### Hillsborough River Interlocal Planning Board AGENDA

TAMPA PORT AUTHORITY (TPA) PERMIT APPLICATION NO. - 09-028  
MINOR WORK PERMIT APPLICATION

**SUBJECT: TPA PERMIT #09-028 / THREE STANDARD PENETRATION TEST BORINGS WITHIN THE HILLSBOROUGH RIVER FOR THE CITY OF TAMPA / APPLICATION RECEIVED BY TPA ON FEBRUARY 13, 2009 / APPLICATION RECEIVED BY EPC ON MARCH 23, 2009 / STR 13-29S-18E**

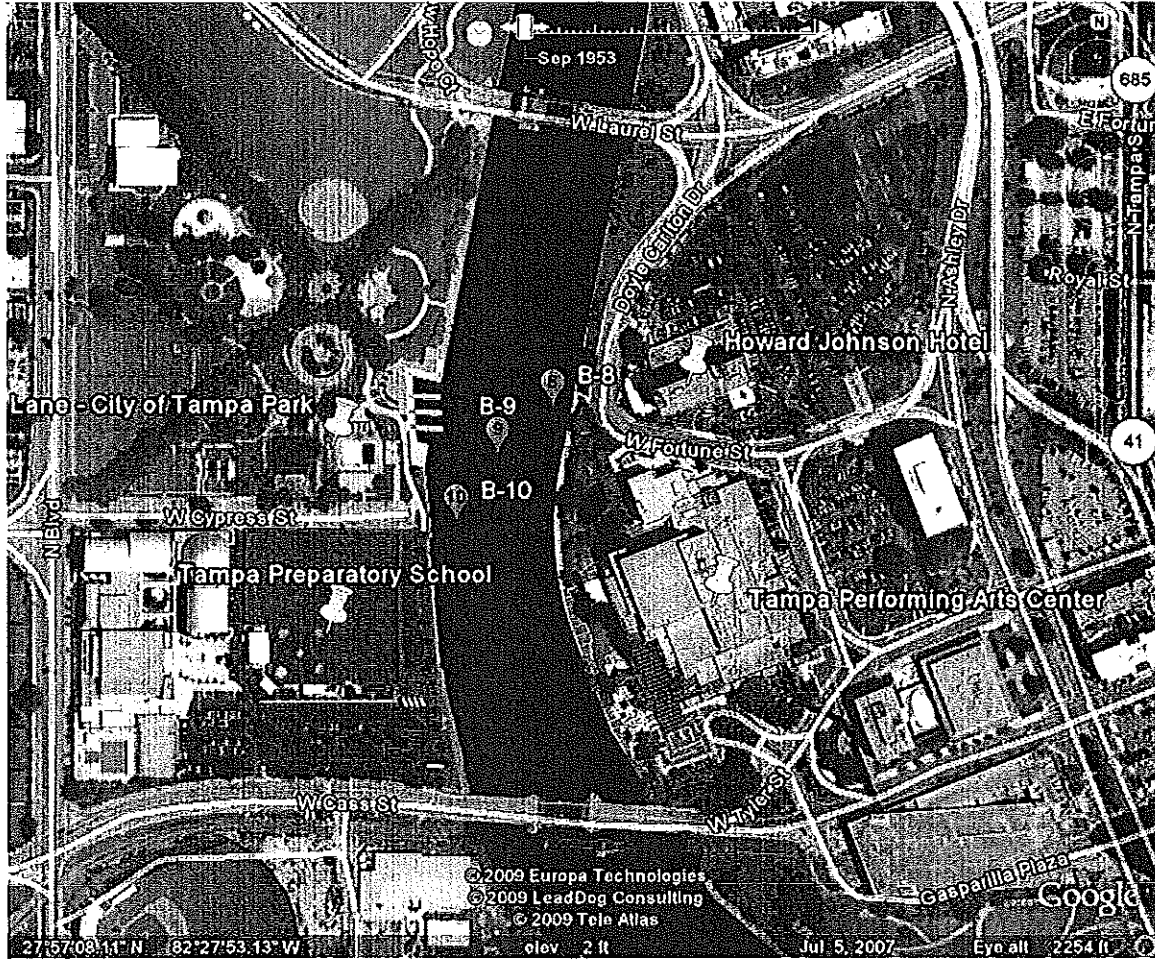
1. All work must be conducted as proposed and in the location indicated by the plans received by EPC on March 23, 2009. Any proposed changes or adjustments must be reviewed and authorized by EPC staff.

TYPICAL BORING DETAIL  
HILLSBOROUGH RIVER

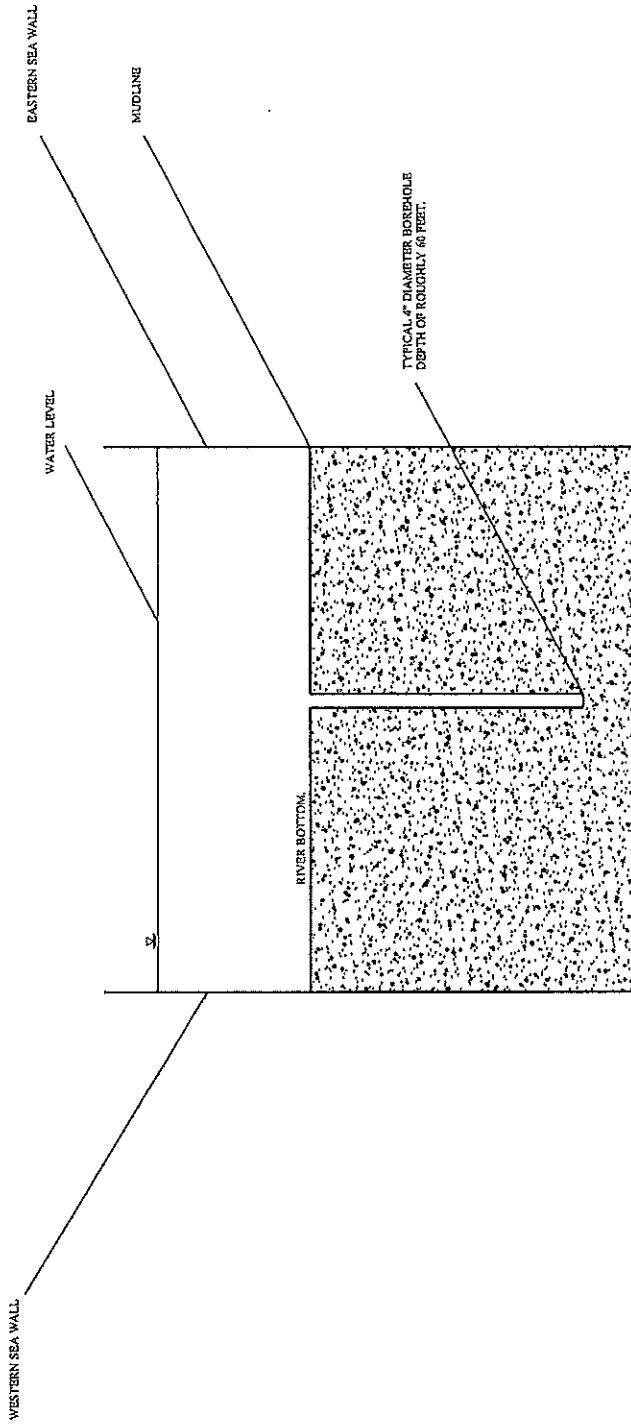
2. All efforts must be undertaken to prevent any erosion or turbid water from being discharged off-site, into the wetlands and/or waters of the County. Turbid discharges that exceed 29 NTU's (Nephelometric Turbidity Units) above background levels are a violation pursuant to Chapter 1-5, the EPC Water Quality Rule. State water quality standards for turbidity shall not be exceeded outside of the immediate area of boring. The staff of the EPC will require the use of a properly installed floating turbidity curtain, to be deployed around the perimeter of the work area. This turbidity curtain shall remain in place until all boring has ceased and all sediment has settled out. It is strongly recommended that the turbidity/erosion control devices be regularly inspected during construction and modified if conditions warrant.

3. A Grout Management and Emergency Spill plan must be in place prior to any boring.
